AGENDA

PTI M-10 Unbonded Tendon Committee

Tuesday, April 26, 2016, 1:00 PM - 5:00 PM

PTI Committee: M-10 Unbonded Tendon Committee	Ballot: M-10-1501	Ballot Start Date:	March 7, 2016
Document Title: M10.3-16, Field Procedures Manual for Unbonded Tendons – Responses to TAB		Ballot End Date:	April 7, 2016
Comments			Extended to April 14, 2016

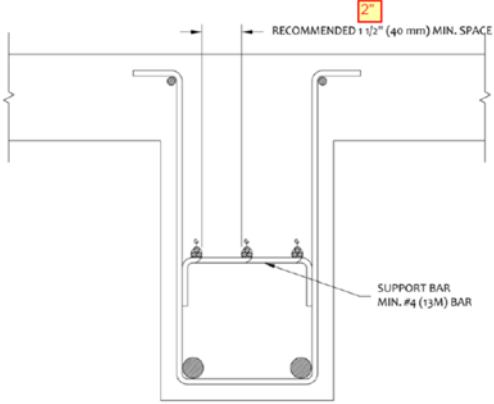
74	16		PRICE Y-C	T	Revise Fig. 4-3a as follows: - Show corner bars in hairpins and add a note pointing to them "Add bars as required to support hairpin in place"; - Add on the end of the #4 backup bar callout, "and placed between hairpin and bearing surface of anchor". - Remove the note "Distributed tendons"; - In plan view, reduce spacing between anchors to show typical placement side-by-side; keep the note about anchorage spacing; remove note "in contact to 1/2 h from..."	OK The #4 back-up bars should extend a minimum of 12-inches beyond the last anchor for full embedment development length or have 90-degree hook at slab corner.
79	17		PRICE Y-C	T	Modify Fig. 4-3b: - Use term "headed shear stud reinforcement" per 318; - Show concrete cover under headed shear stud plate; - Add on the end of the #4 backup bar callout, "and placed between hairpin and bearing surface of anchor". - Reduce spacing between anchors in plan view to show typical placement side-by-side; keep the note about anchorage spacing.	OK The #4 back-up bars should extend a minimum of 12-inches beyond the last anchor for full embedment development length or have 90-degree hook at slab corner.

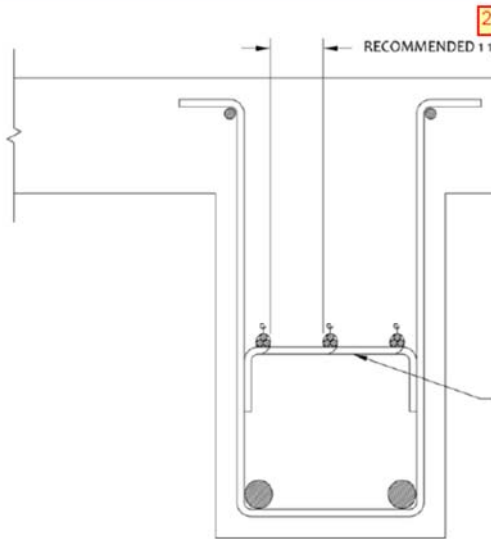
87	21	13	Krauser N	T	Recommend following:	OK Why 2" – it should be 2 x size of concrete aggregate
